Technical Review Comments on Emma Project Hydrogeologic Assessments

New Mexico Mining and Minerals Division Public Hearing
Silver City, NM August 16, 2022

Dylan Duvergé P.G., Stratus Environmental LLC
On behalf of
Gila Resources Information Project (GRIP)

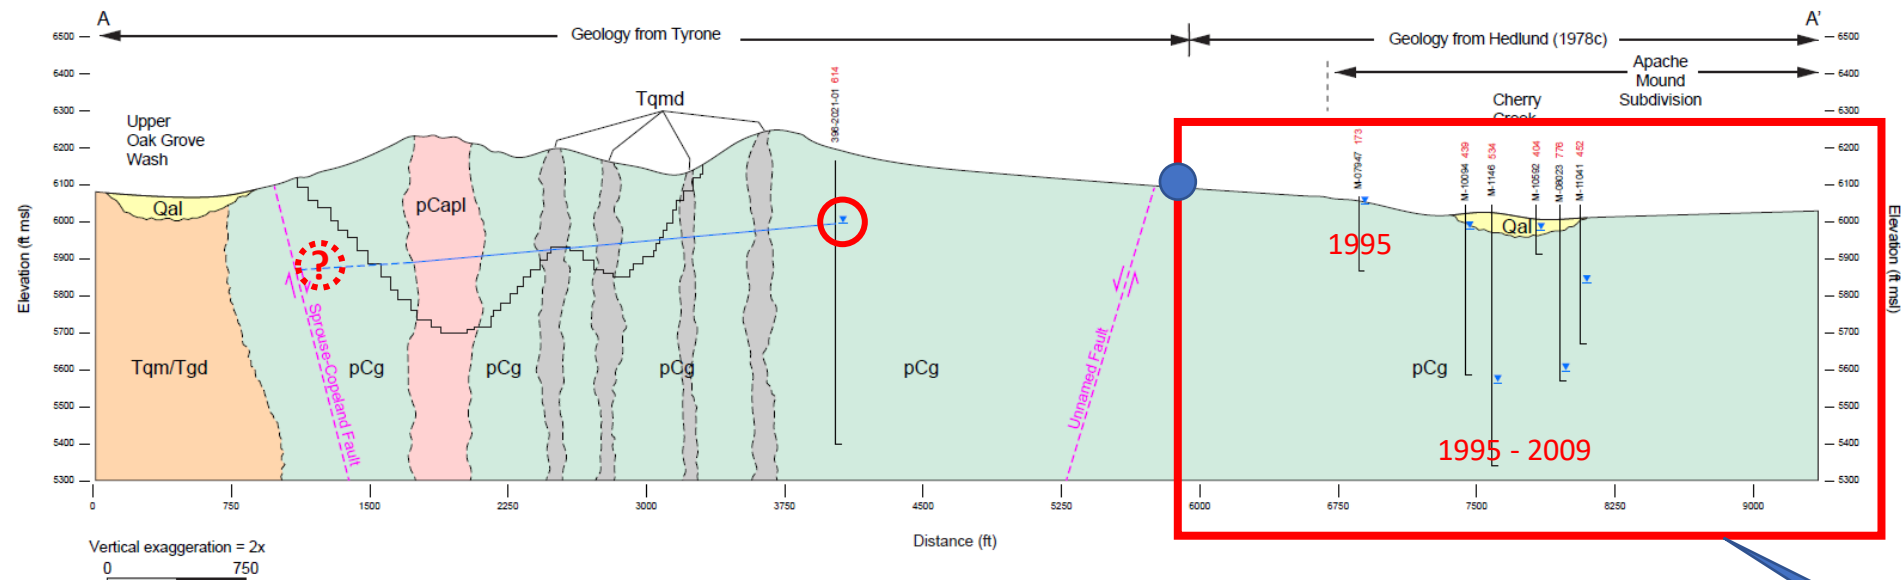
ADDED

- Cherry Creek springs

TYRONE MINE
Generalized Hydrogeologic Cross Section A-A'

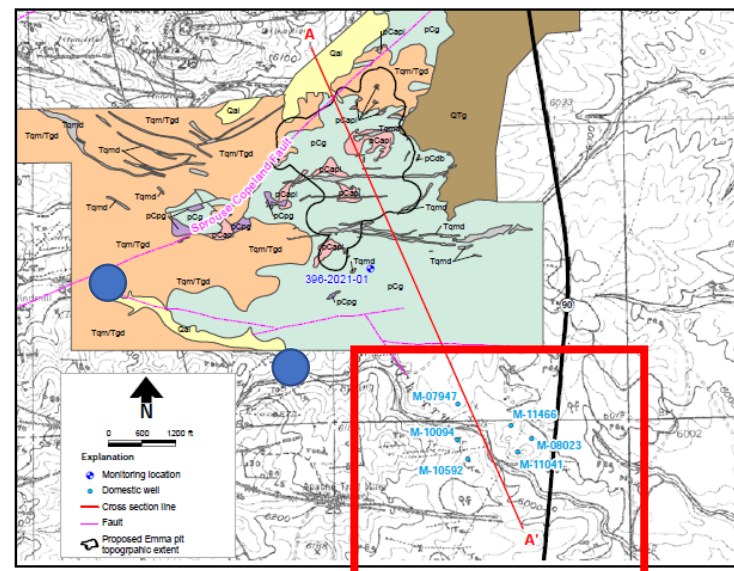
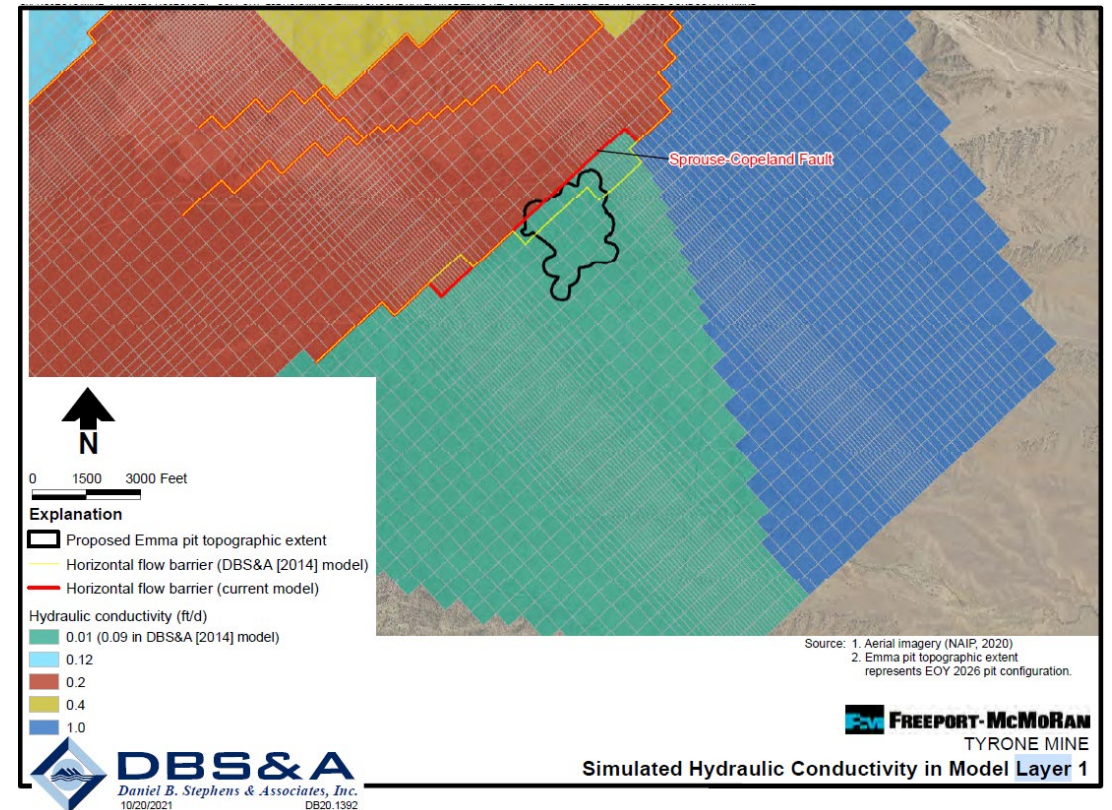
- Highly Heterogeneous
- Faults can impede or facilitate groundwater flow
- Groundwater moves through intersecting fractures and mineralized zones
- Tertiary quartz monzonite dikes are discontinuous in places
- Springs are important indicator of surfacing groundwater (0.4 miles South of Emma boundary)
- Little is known south of Emma

Little is known about this area. Groundwater level data is old.

Domestic Wells – The Big Black Box

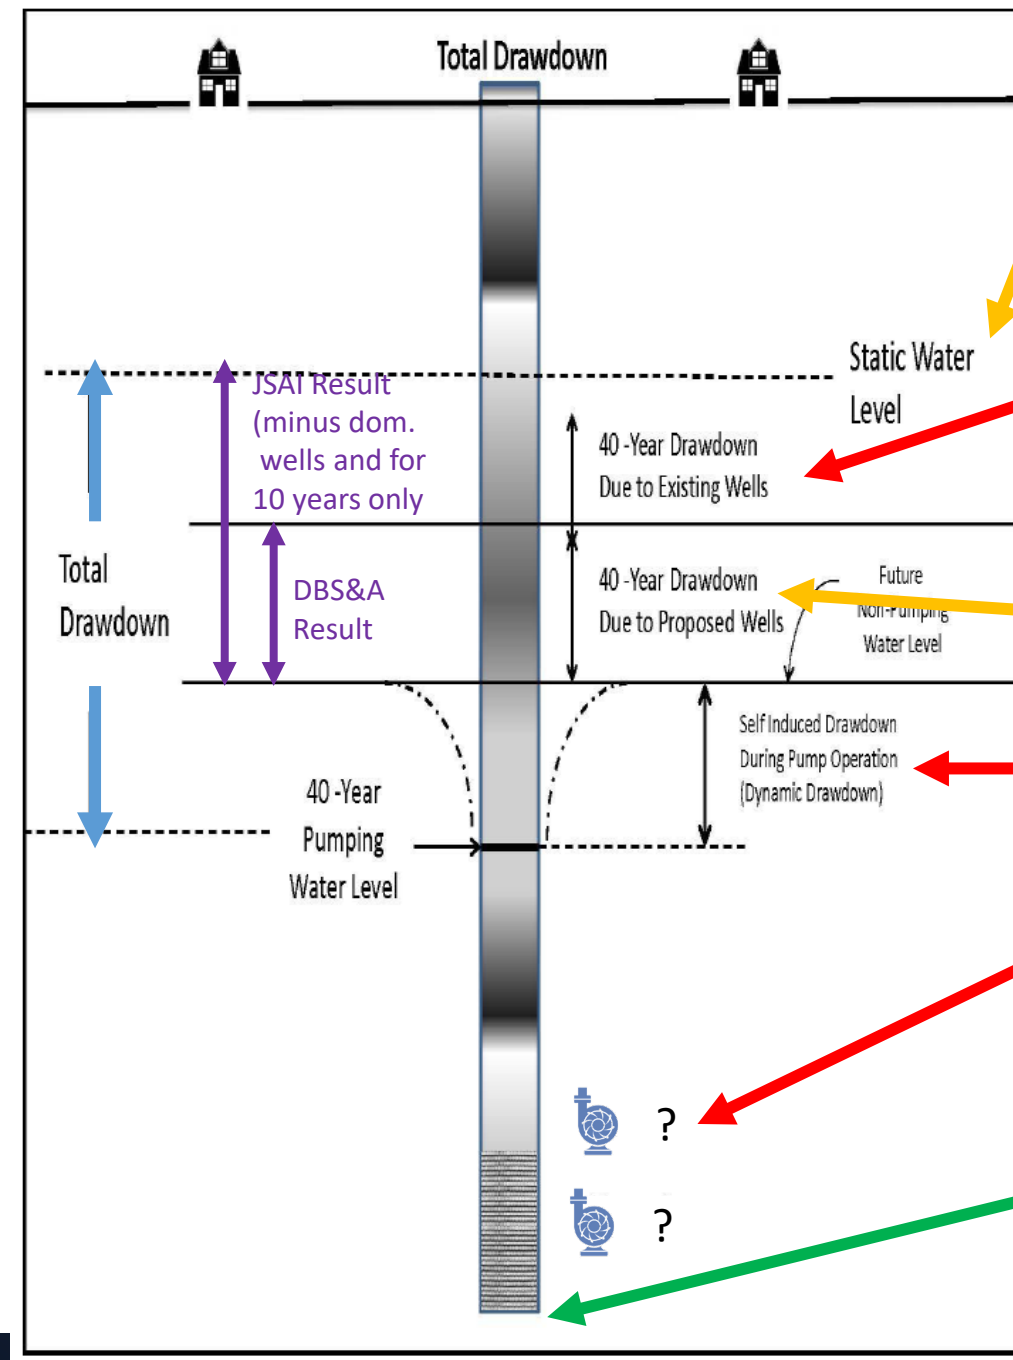
- Information is provided DBS&A and JSAI reports are limited to OSE logs
- Wells have poor yields that rely on very narrow producing zones (both are predominantly in single digits)
- Some evidence groundwater levels have been declining
- Wells likely to have large dynamic drawdowns
- JSAI relies on blanket threshold for Lowest Practical Pumping Level (LPPL) rather than a calculation of total drawdown vs pump setting

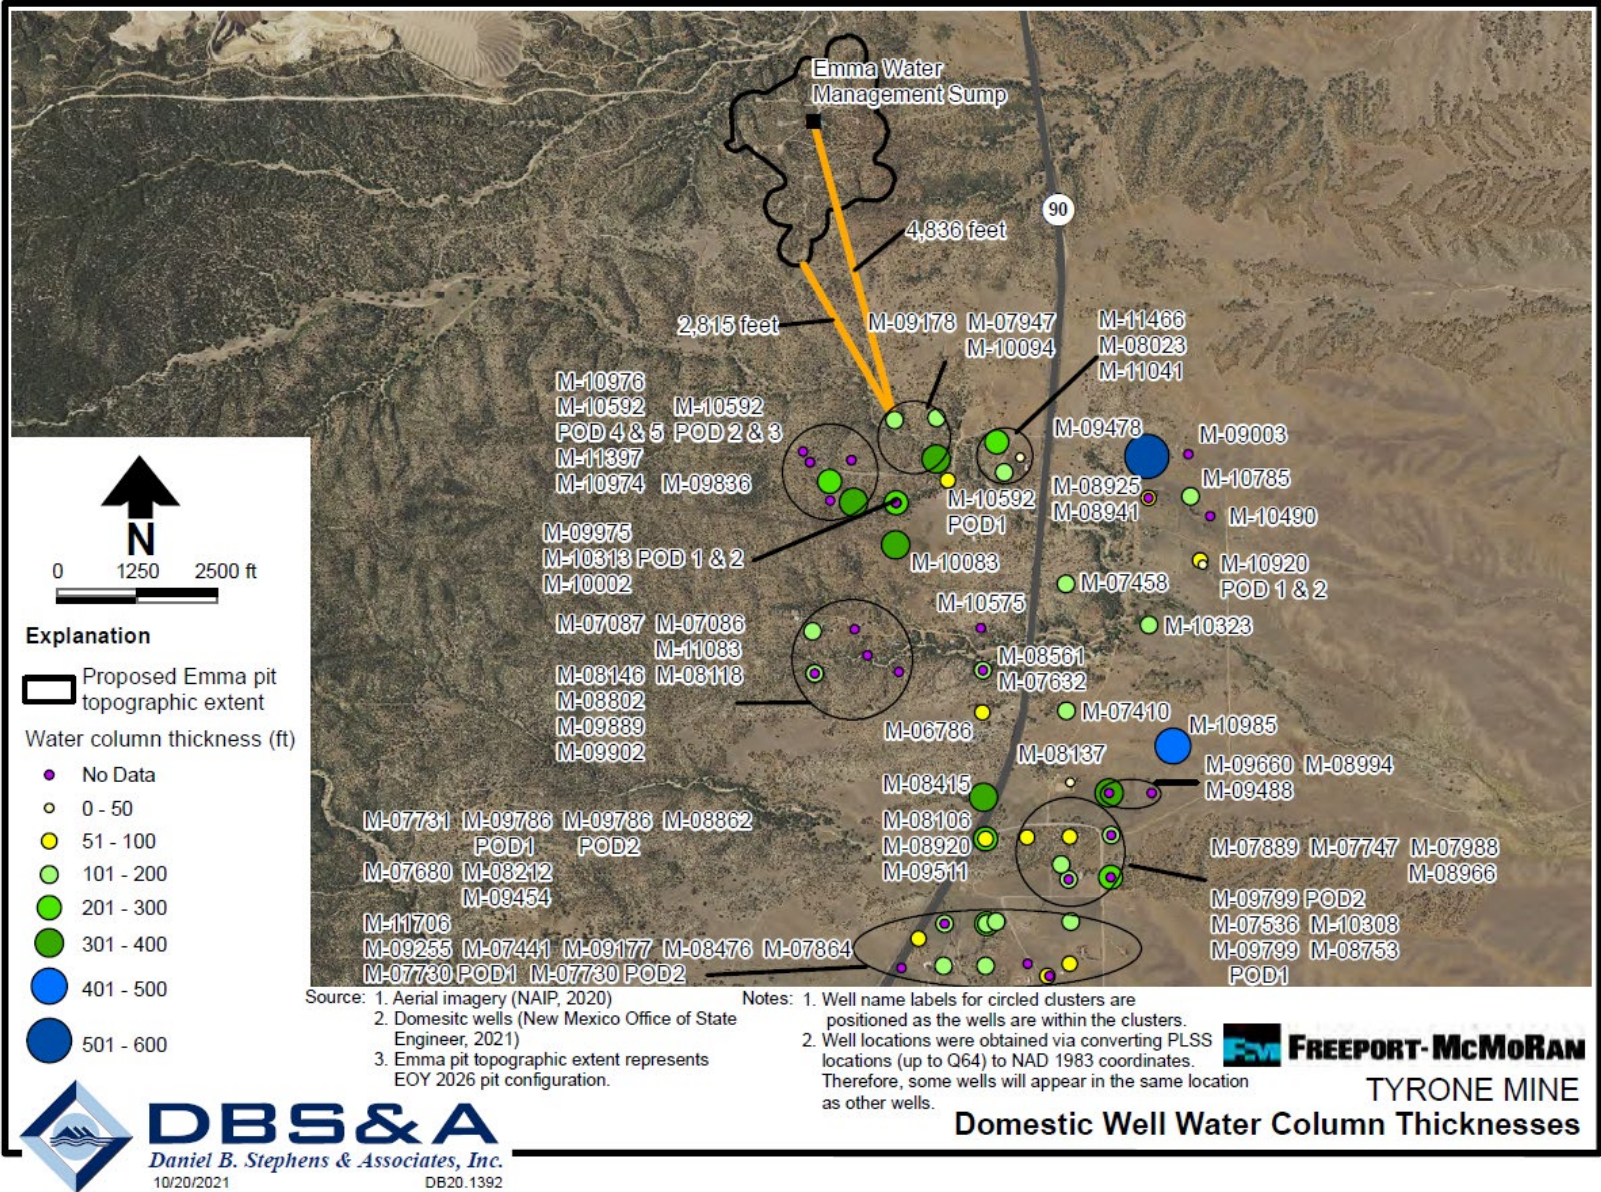
- Uncertain**
(Water level data from OSE logs is up to 100 years old)
- Existing domestic water rights not included in the analyses**
(existing FMI rights were included in the JSAI report)
- Uncertain**
(Issues with model assumptions/validation)
- Not included in the analysis**
- Not included in the analysis**
(Locations of well pumps should be considered)
- Well depth is the only thing we know for sure from OSE logs**

In making an impact determination, it is inappropriate to compare drawdowns to water column thickness
